Fwd: Window and Door Quote

Thank you for your quotation (Quote No: PA 4471) and cross sections which are enclosed here for your easy reference.

Project Title : **2 Rapere St, Rolleston - Door Only**

Quote No: PA 4471

Screenshot 1: Elevation of Sliding Door with marked Section A-A

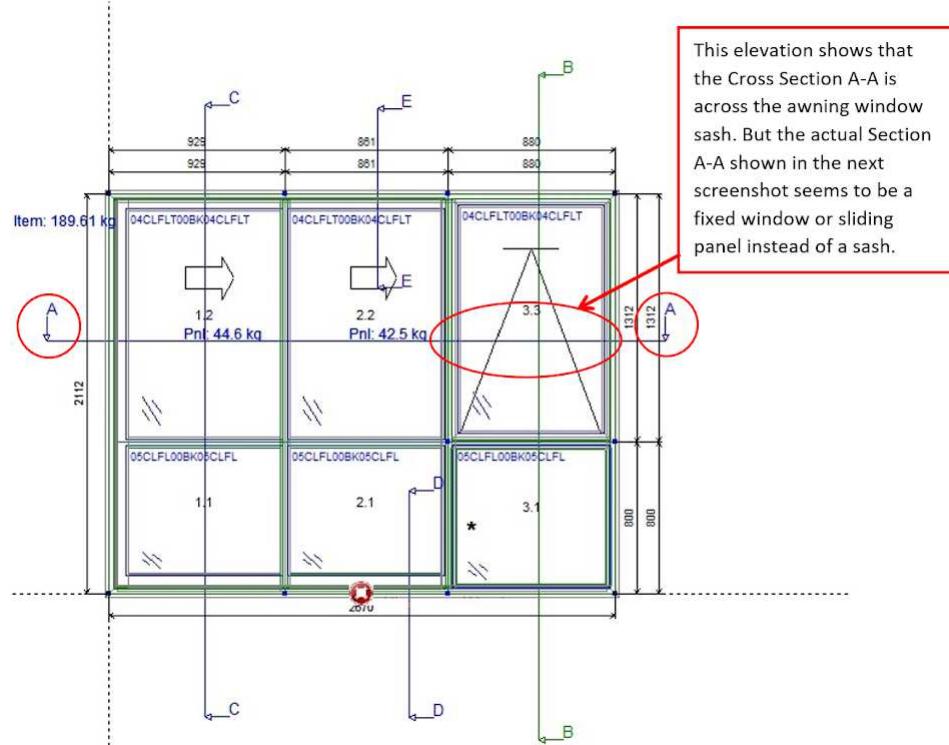
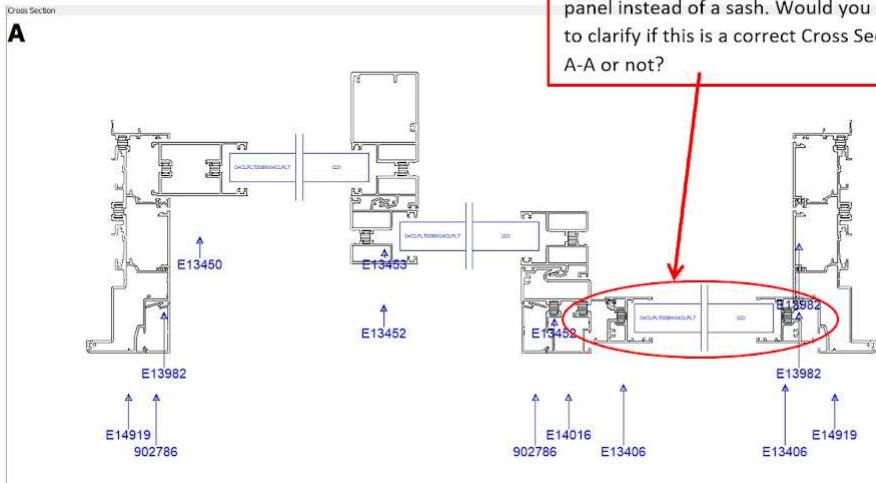
Regarding the cross sections, I wonder if your given cross section A-A is not the one across the awning window sash above the window transom. It is because it seems to be a left-most fixed window or sliding panel instead of a sash (see the description and question on screenshots of the cross section A-A and elevation).

Would you mind clarifying if the cross section A-A is correct or not? Would you mind if I visit you having a chat about the cross sections?

Cross Section A - Stacker .jpg
88K

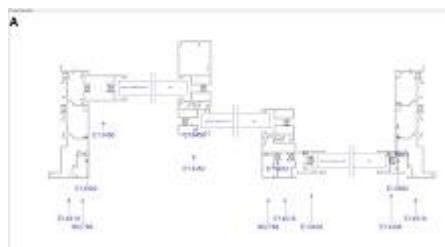
1. The cross sections of the 7 sliders which show all the aluminium members are thermally broken.
2. Can you provide the 7 sliders with coal dust colour or similar dark colour?

Please see attached pictures for the cross sections of our Thermally broken suite.
